**NEW YORK STATE THRUWAY AUTHORITY  
DEPARTMENT OF ENGINEERING**

**AMENDMENT NO. 1  
TO**

**CONTRACT TAS 26-10A  
D215078  
PORT BYRON SERVICE AREA  
WATERMAIN REPLACEMENT  
AT I-90, MILEPOST 310.20  
IN THE SYRACUSE DIVISION  
OF THE NEW YORK STATE THRUWAY  
IN CAYUGA COUNTY**

**IN THE LETTING OF  
JANUARY 7, 2026**

TITLE OF PROJECT <b>WATER MAIN REPLACEMENT</b>		CONTRACT NUMBER: <b>TAS: 26-10A</b>
LOCATION OF PROJECT <b>PORT BYRON SERVICE AREA (MP 310.2)</b>		DATE: <b>12/19/2025</b>
TITLE OF DRAWING <b>PLAN &amp; PROFILE STA: 5+50 TO 11+00</b>		DRAWING NUMBER: <b>PP-02</b>

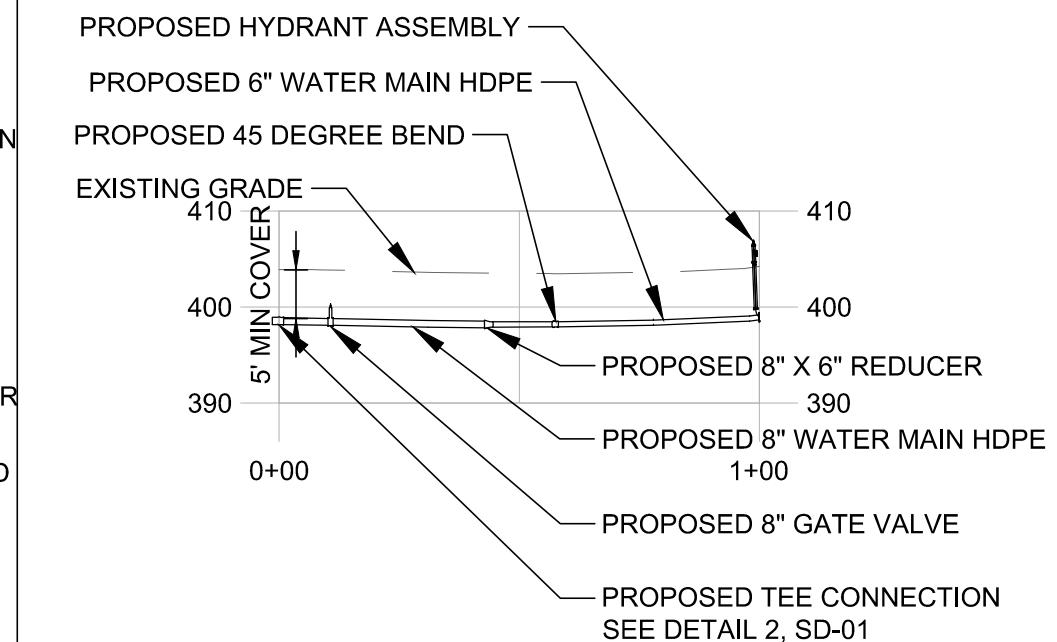
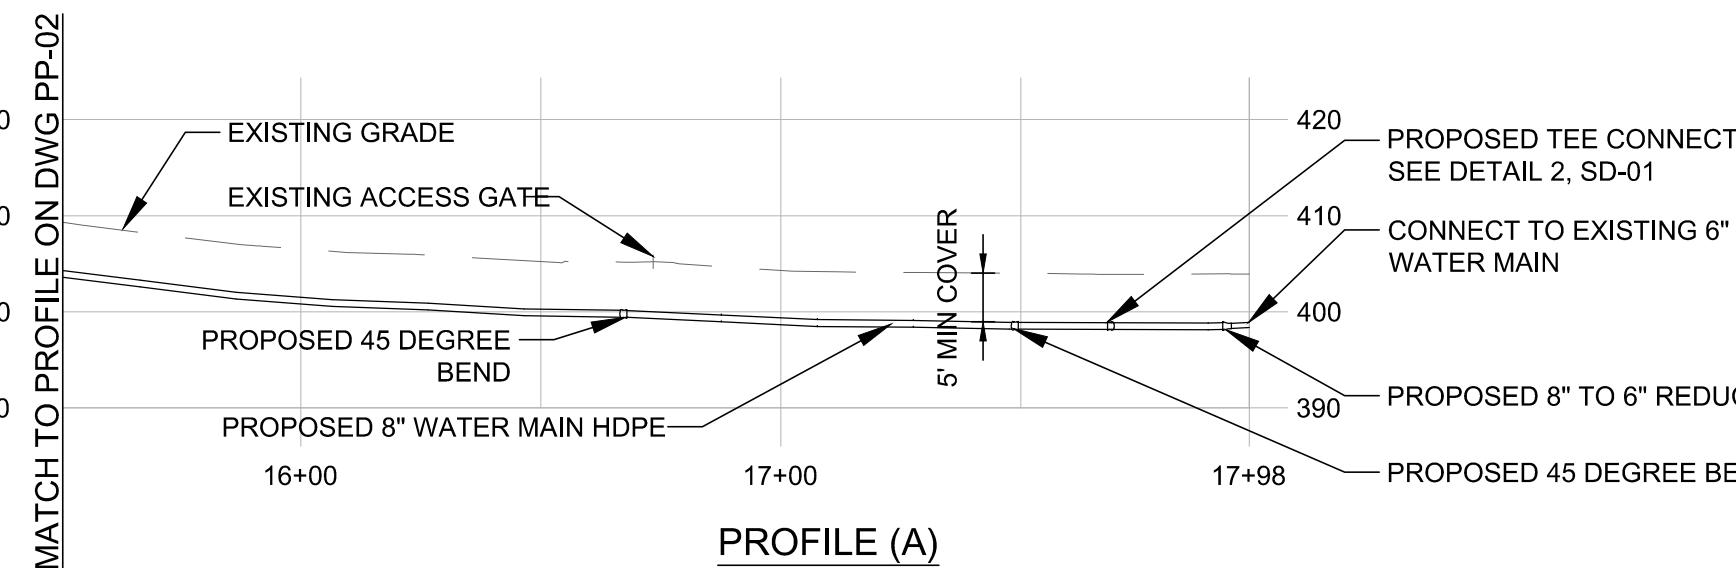
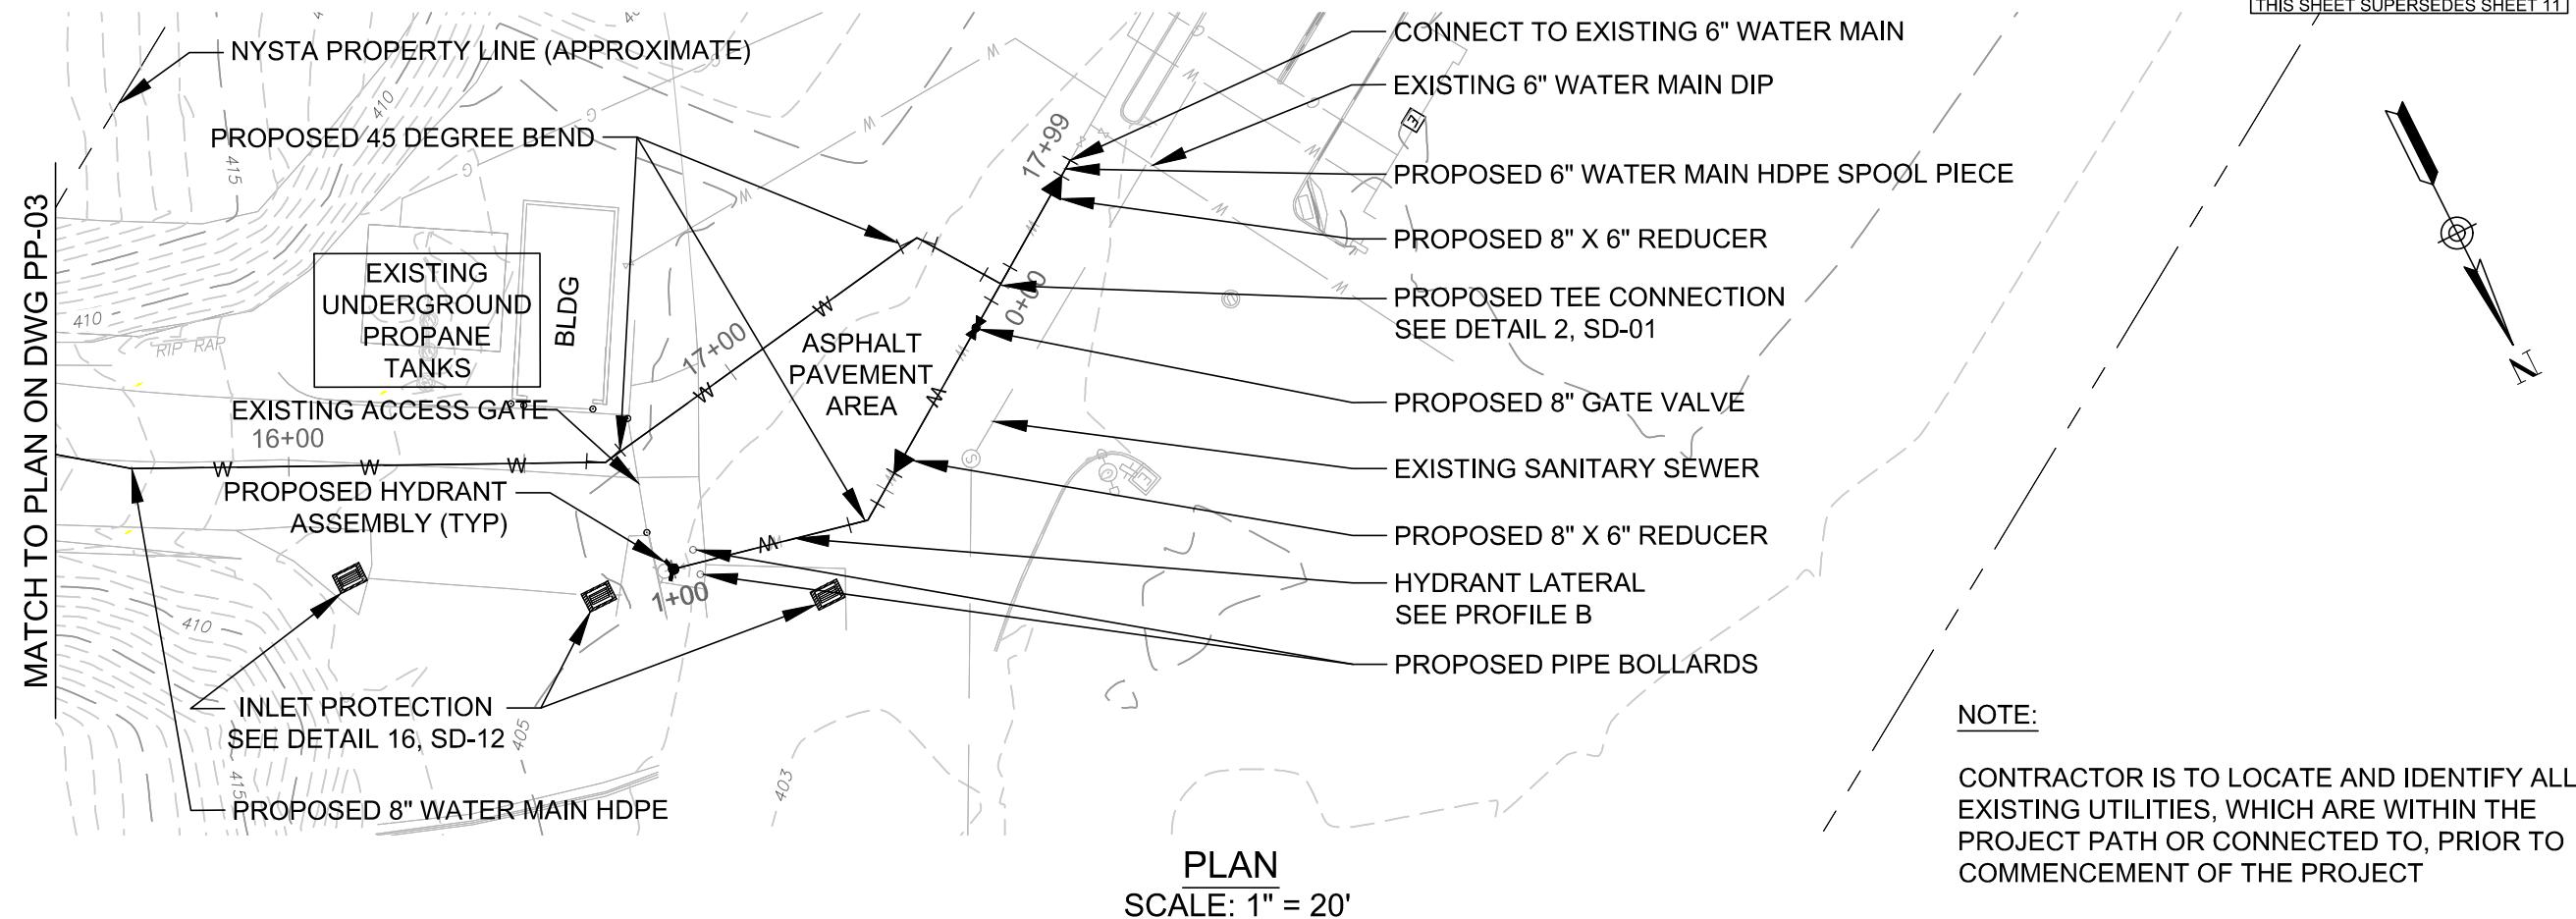
4. **DELETE** Drawing Number PP-02, Sheet 9 of 25 and **SUBSTITUTE** with the attached Drawing Number PP-02, Sheet 9-A1 of 25. Previous references to the proposed Ductile Iron Pipe (DIP) have been updated with HDPE (High Density Polyethylene), instead.

TITLE OF PROJECT	WATER MAIN REPLACEMENT	CONTRACT NUMBER:
LOCATION OF PROJECT	PORT BYRON SERVICE AREA (MP 310.2)	TAS: 26-10A
DATE:	12/19/2025	
TITLE OF DRAWING	PLAN & PROFILE STA: 11+00 TO 15+50	DRAWING NUMBER:
		PP-03

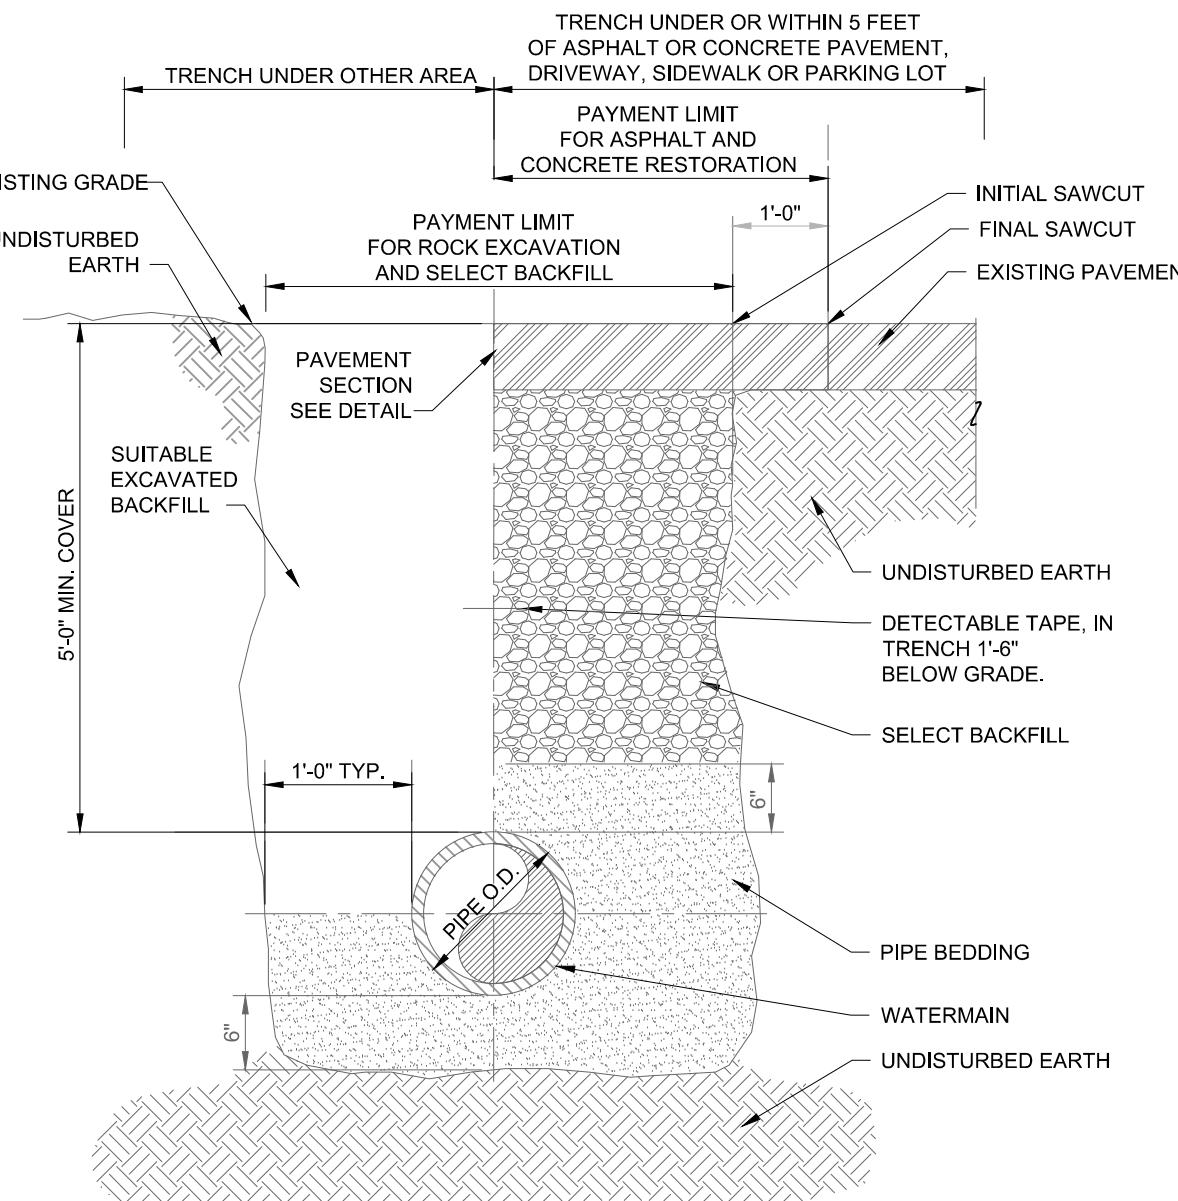
5. **DELETE** Drawing Number PP-03, Sheet 10 of 25 and **SUBSTITUTE** with the attached Drawing Number PP-03, Sheet 10-A1 of 25. Previous references to the proposed Ductile Iron Pipe (DIP) have been updated with HDPE (High Density Polyethylene), instead.

TITLE OF PROJECT WATER MAIN REPLACEMENT	CONTRACT NUMBER: TAS: 26-10A
SYRACUSE (BA)	
120 MADISON SUITE 200 SYRACUSE, NY 13202 PHONE: 315.422.5200 COLLIERS ENGINEERING & DESIGN, ARCHITECTURE, LANDSCAPE, SURVEYING CT, P.C.	DRAWING NUMBER: PP-04

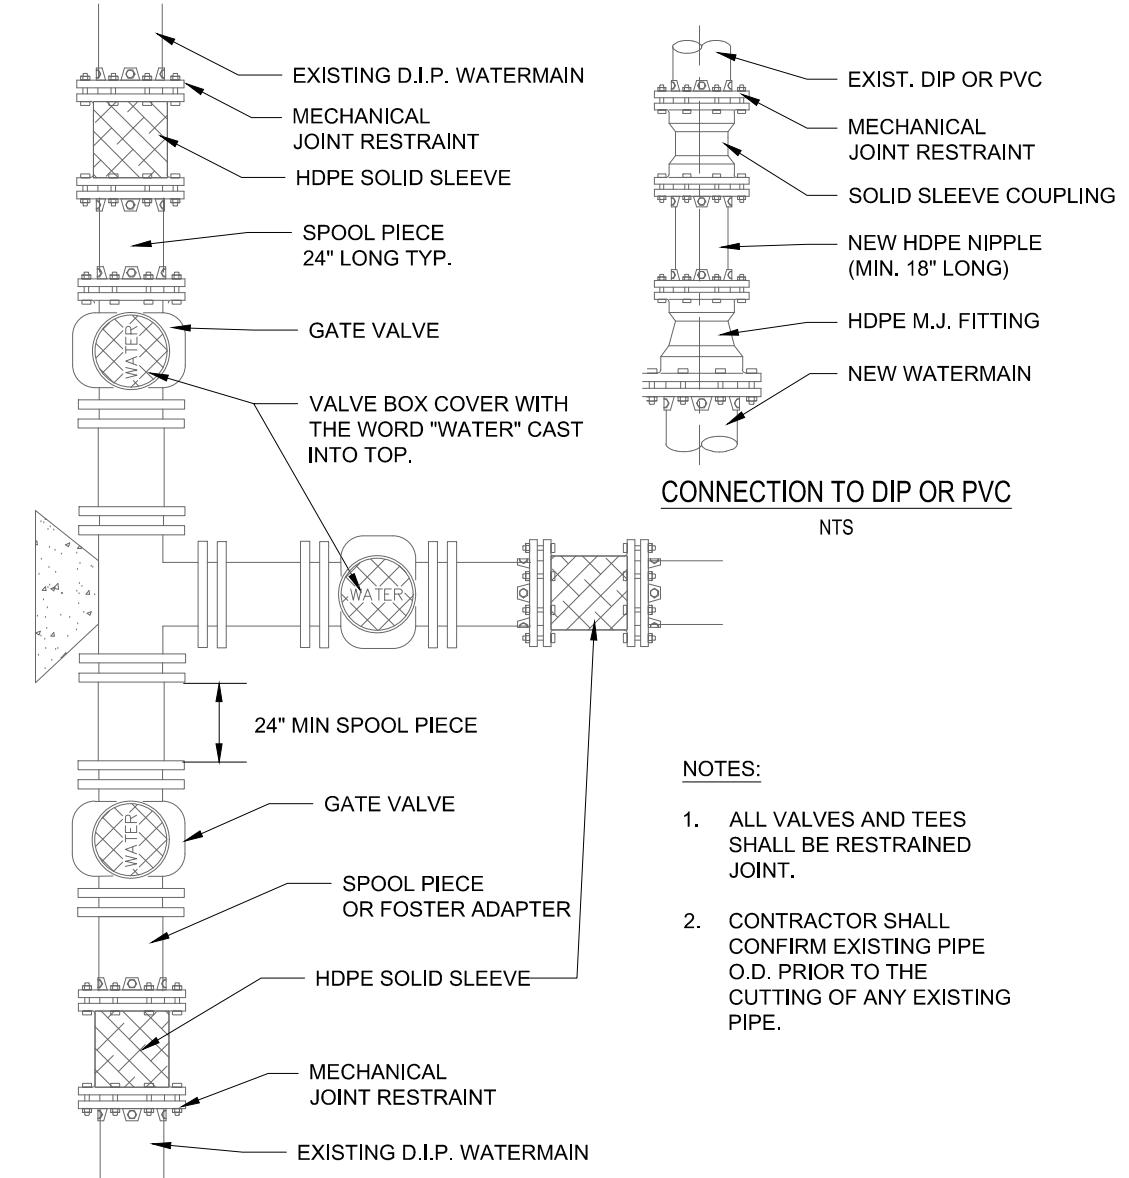
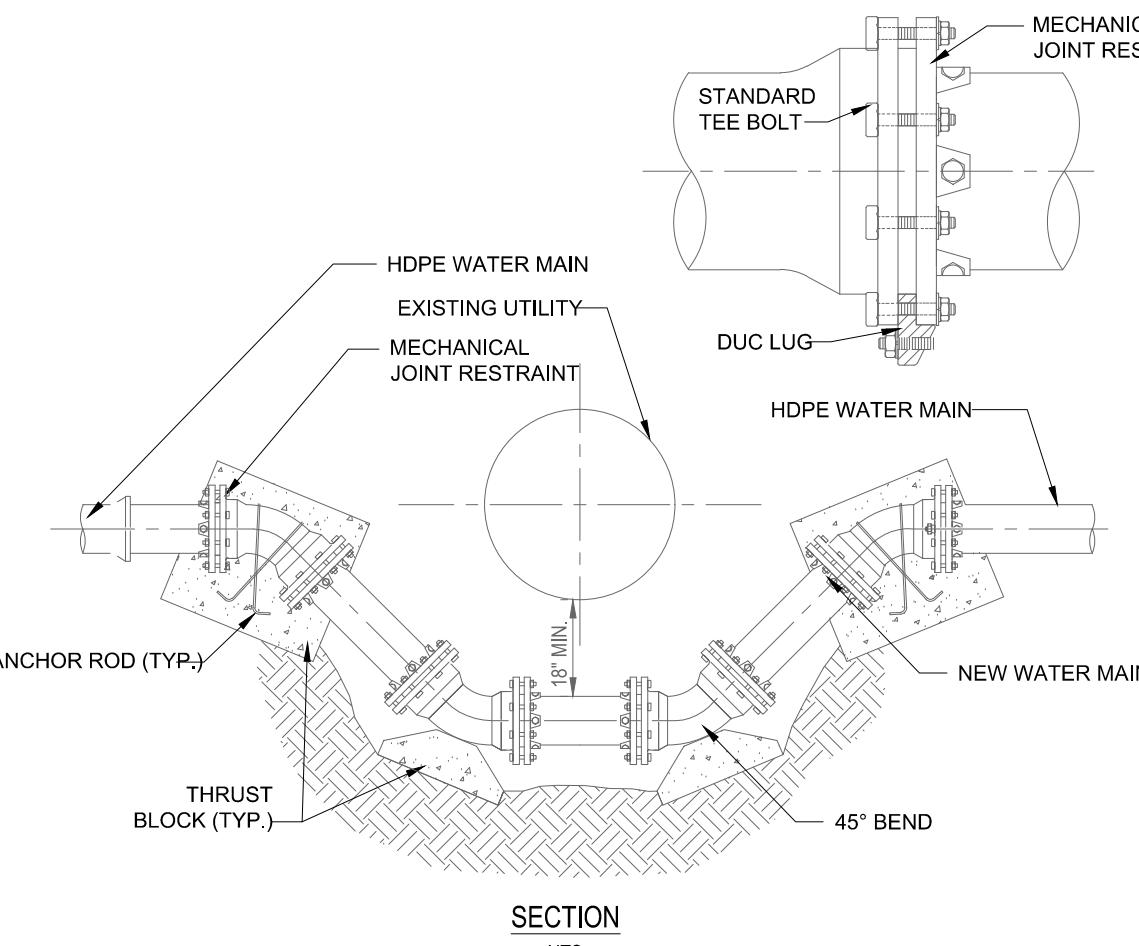
6. **DELETE** Drawing Number PP-04, Sheet 11 of 25 and **SUBSTITUTE** with the attached Drawing Number PP-04, Sheet 11-A1 of 25. Previous references to the proposed Ductile Iron Pipe (DIP) have been updated with HDPE (High Density Polyethylene), instead.

TITLE OF PROJECT	WATER MAIN REPLACEMENT	CONTRACT NUMBER:
LOCATION OF PROJECT	PORT BYRON SERVICE AREA (MP 310.2)	TAS: 26-10A
DATE:	12/19/2025	
TITLE OF DRAWING	SITE DETAILS (1 OF 10)	
DRAWING NUMBER:	SD-01

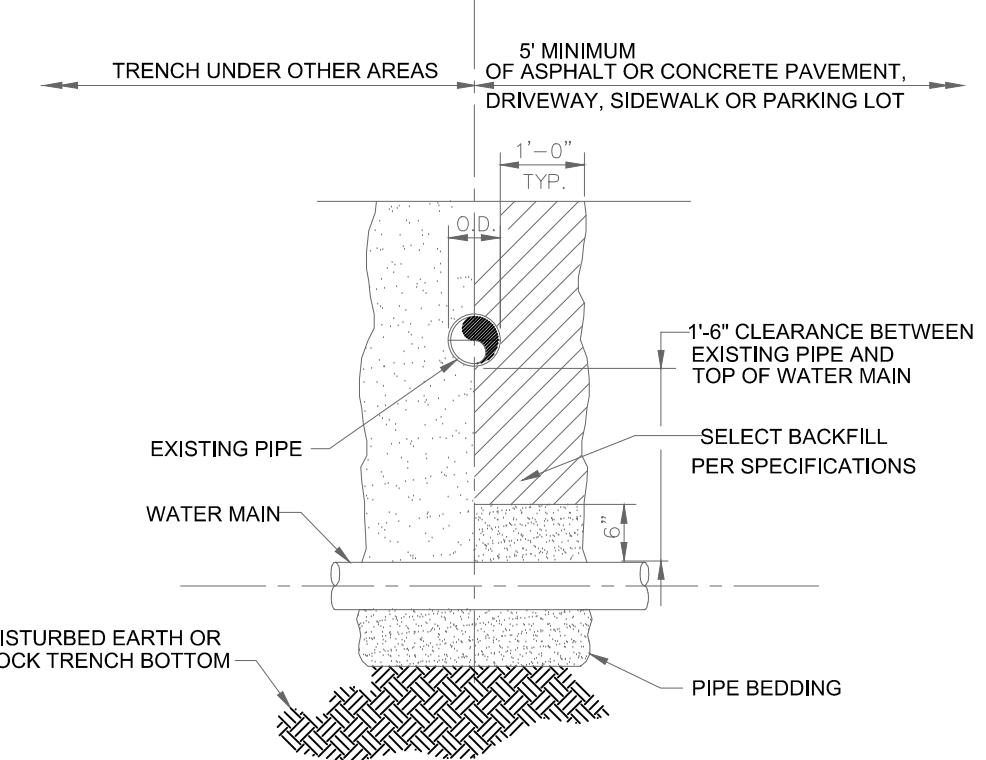
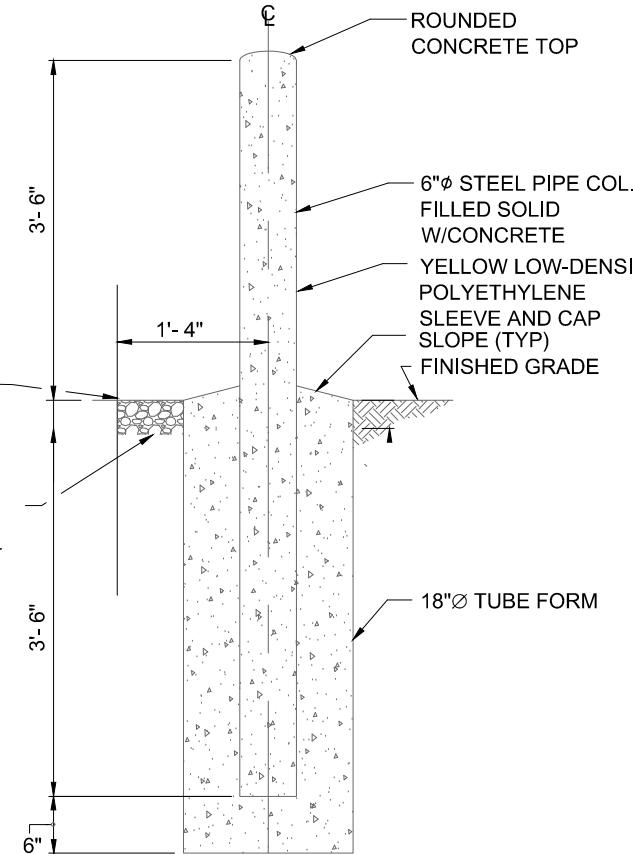
7. **DELETE** Drawing Number SD-01, Sheet 14 of 25 and **SUBSTITUTE** with the attached Drawing Number SD-01, Sheet 14-A1 of 25. Previous references to the proposed Ductile Iron Pipe (DIP) have been updated with HDPE (High Density Polyethylene), instead.

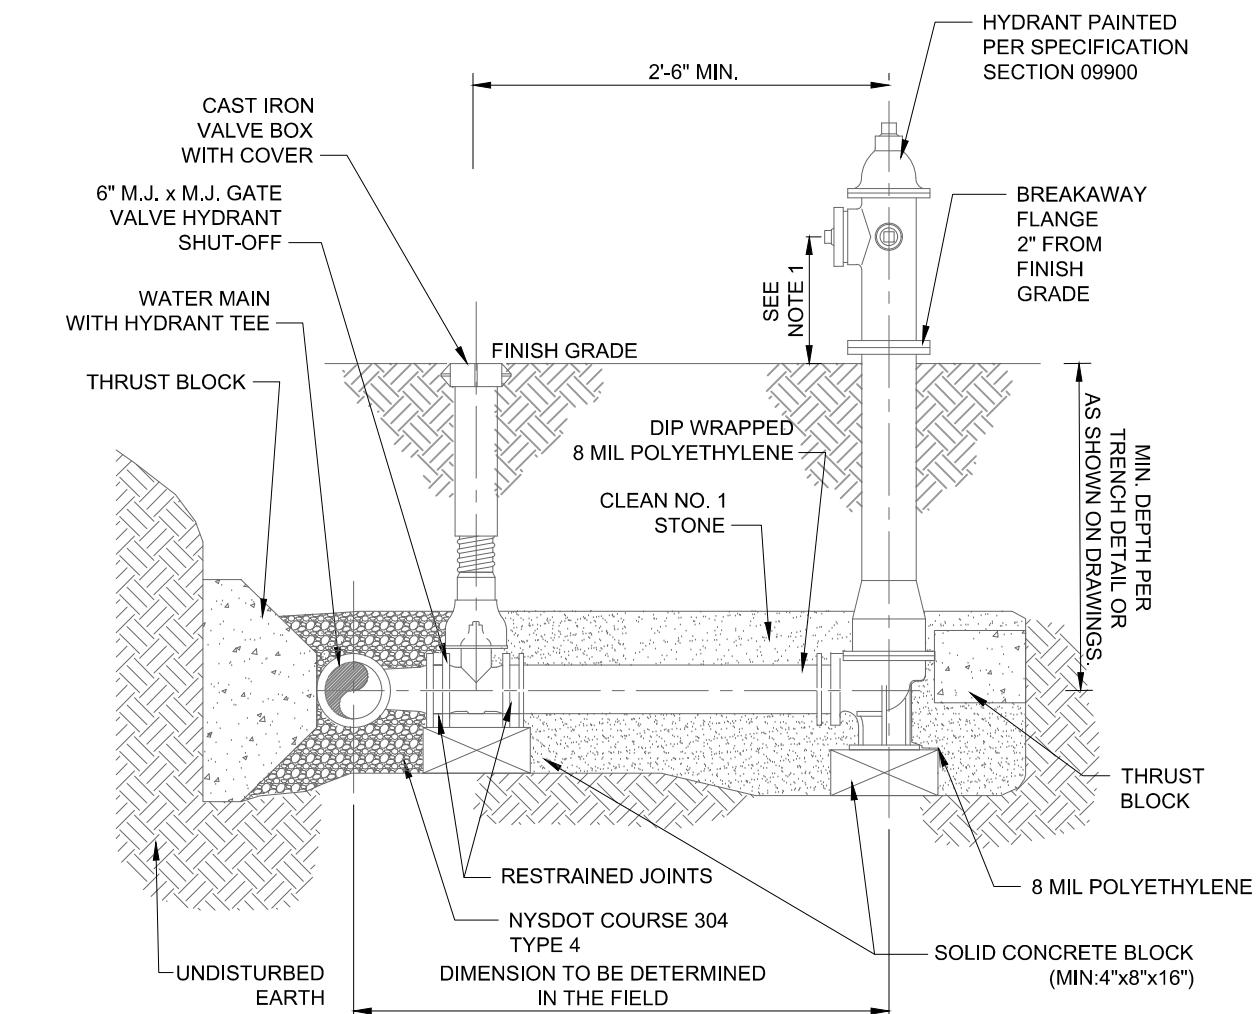
8. **DELETE** Drawing Number SD-02, Sheet 15 of 25 and **SUBSTITUTE** with the attached Drawing Number SD-02, Sheet 15-A1 of 25. Previous references to the proposed Ductile Iron Pipe (DIP) have been updated with HDPE (High Density Polyethylene), instead.
